IN STRUCTURE (Sheet 1 of 3)

STANDARD 812001-01

RACEWAYS EMBEDDED IN STRUCTURE

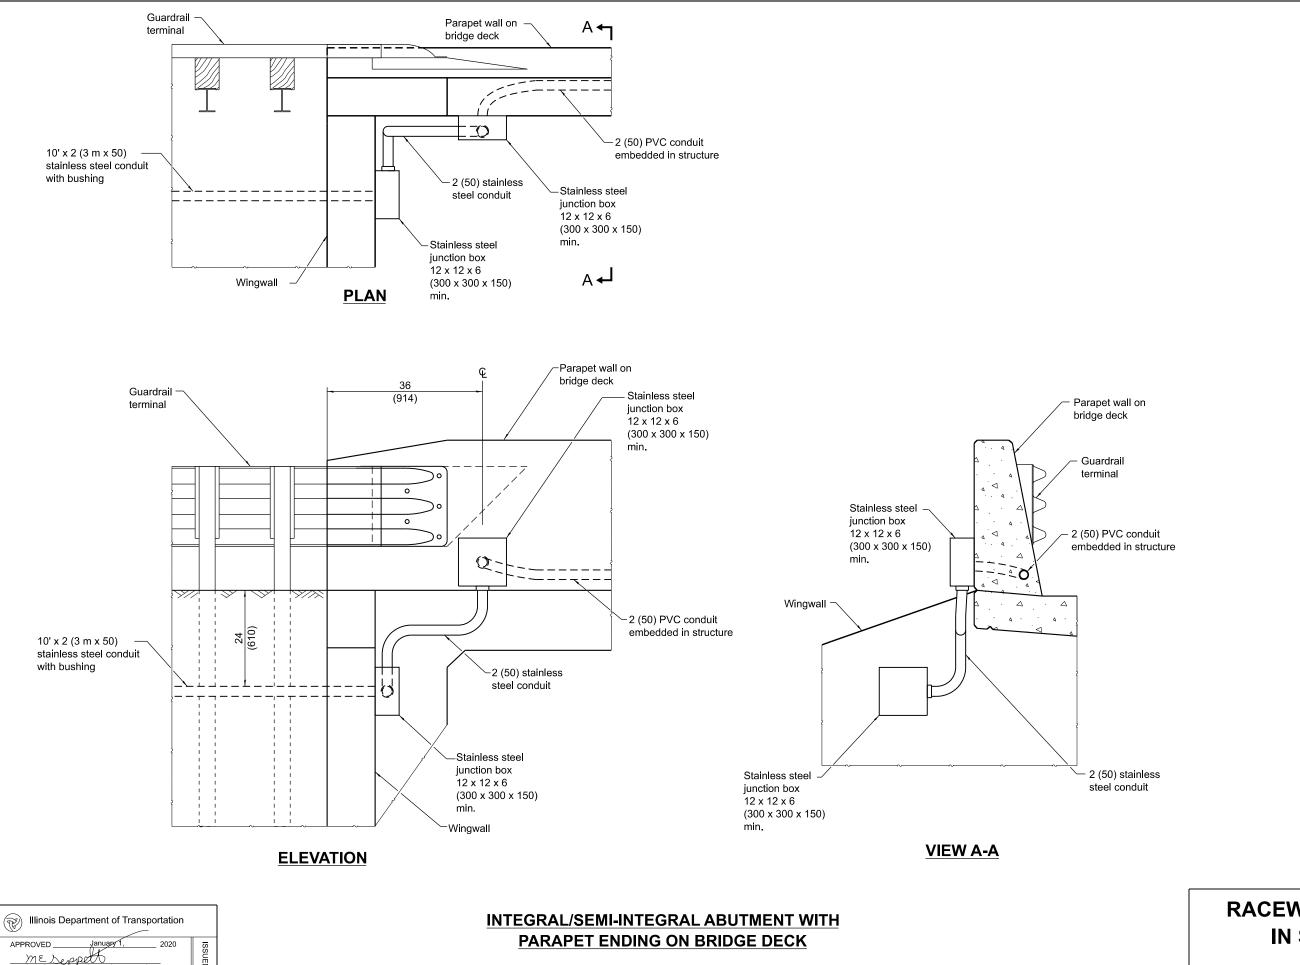
slop parapet, added general note for

steel connector plate, revised

standard name, and fixed typo.
